SEWAGE DISPOSAL SYSTEM

DEPARTMENT OF HEALTH AND MENTAL HYGIENE

SUBDIVISION Sharp Farms

LOT 34

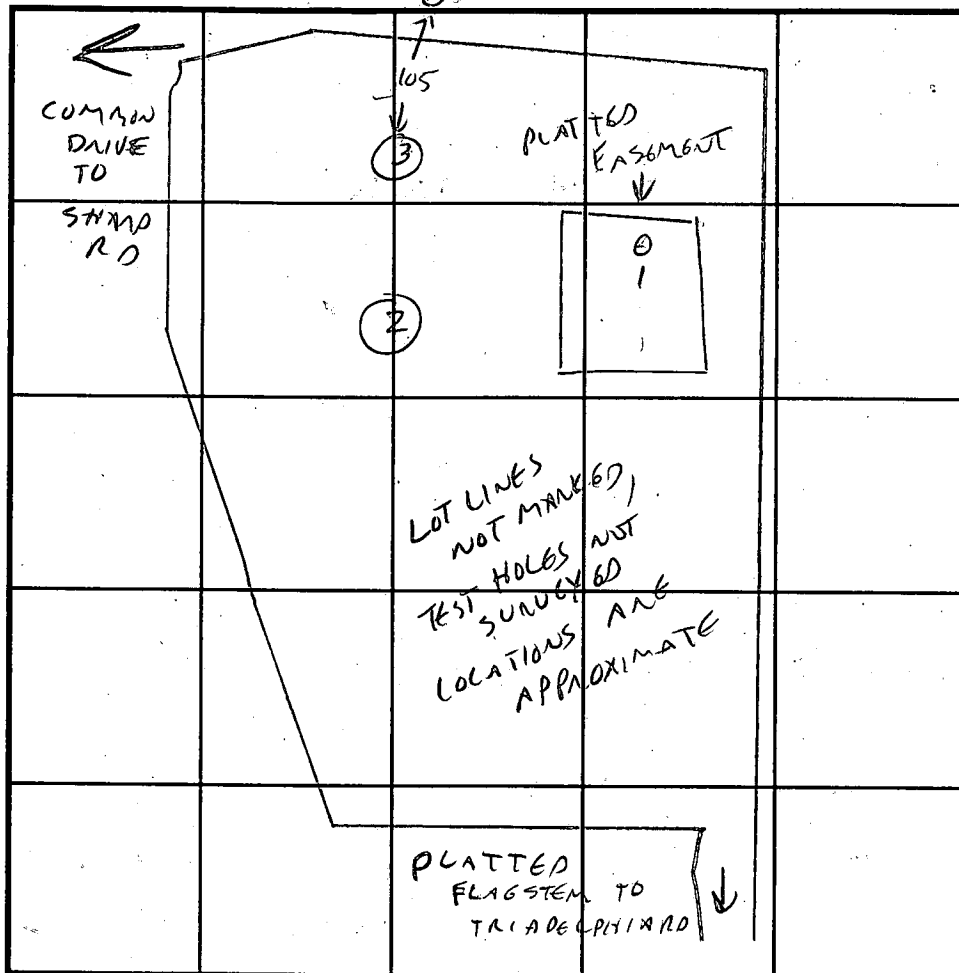
0'
#1
CLAY
CLAY LOAM 4'
SILT LOAM 6'
MOTTLED 11'
12'

#2
CLAY
SILT LOAM 6'
SATURATED TO 7'
WATER 10'

#3
SIMILAR TO #1 BUT LOWER ON LANDSCAPE AND CLOSER TO NEIGHBORING WELL

DATE	TEST NO.	DEPTH	PRE-WET		TEST - 1" DROP		TIME	
			START	STOP	START	STOP		
11/3/97	1	6	2:05	2:12	2:12	2:24	12	
		12	VIS OK	LOAM	6-11'			
			NO WATER, MOTTLED AT				11-12'	
	2	VISUAL UNACCEPTABLE						
		CLAY TO 6' WATER AT 10'						
		SOILS SATURATED TO						7'
	3	SIMILAR TO HOLE 1, BUT NOT RECOMMENDED FOR						
		DEEP CLAY, MOTTLED AT 11', LOWER ON LOT 9						
		CLOSER TO NEIGHBORING WELL -						
		TRENCH DESIGN DATA: AVERAGE PERCOLATION TIME						11'

REMARKS CONDITIONS IN HOLE 3 "RIPE" FOR GREATER THAN USUAL CHANGE IN WATER TABLE

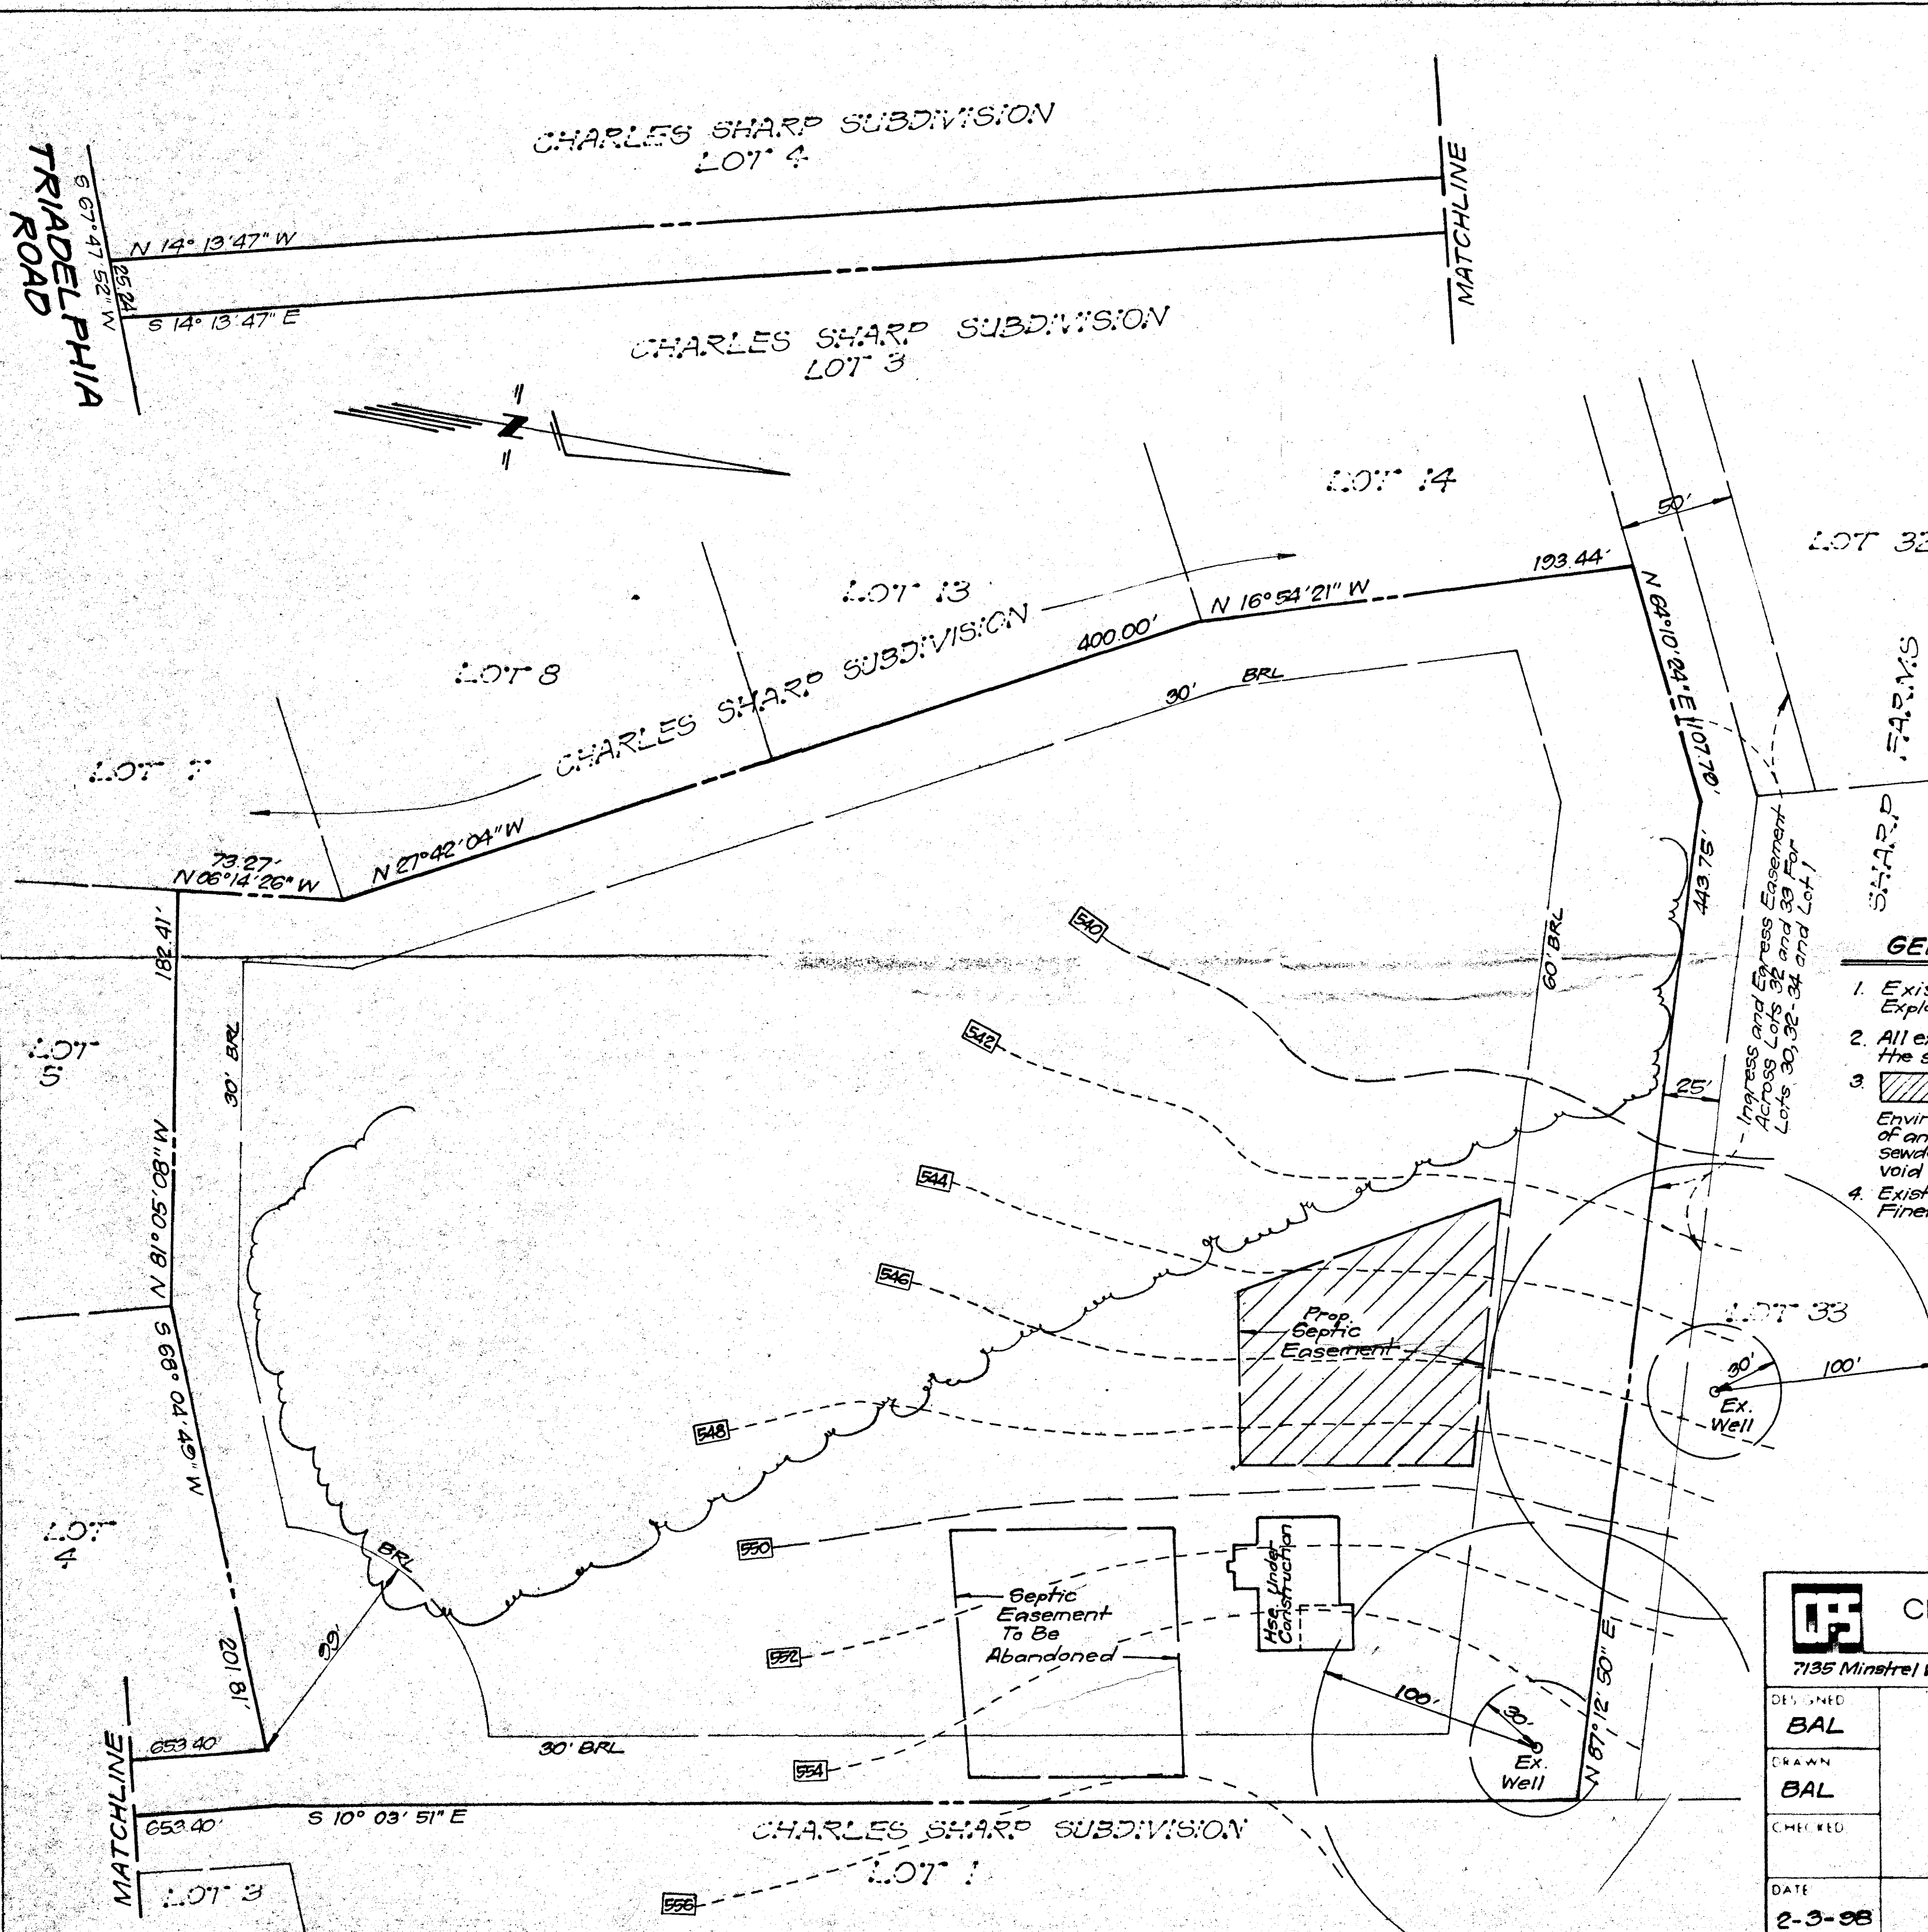
BRYAN - WITH 20' BUFFER HOUSE → SEPTIC,
MORE THAN HALF THE AREA IS LOST.

WET SEASON TESTING WOULD BE NEEDED
FOR FINAL DETERMINATION AND EVEN THEN
IT WOULD BE "PUSHING THE REVIEWER'S JUDGEMENT"
ON IMPACT OF FUTURE FLUCTUATIONS IN WATER TABLE.
THAT'S A BAD RISK!

SURELY THAT'S NOT THE ONLY SUITABLE HOUSE POSITION

PLUS - IF YOU ONLY HAVE MINIMUM SEPARATION BETWEEN
HOUSE & SEPTIC NOW, YOU'VE LOCKED YOURSELF OUT OF
FUTURE DECK - PATIO - POOL IN ANY NORMAL CONFIGURATION.
PICK A SITE AWAY FROM THE SEPTIC, PUMP THE SEWAGE, & ENJOY THE LOT.

UPON RECONSIDERATION/
MODIFICATION
ACCEPTED AS
PROPOSED.
1/26/98
CW
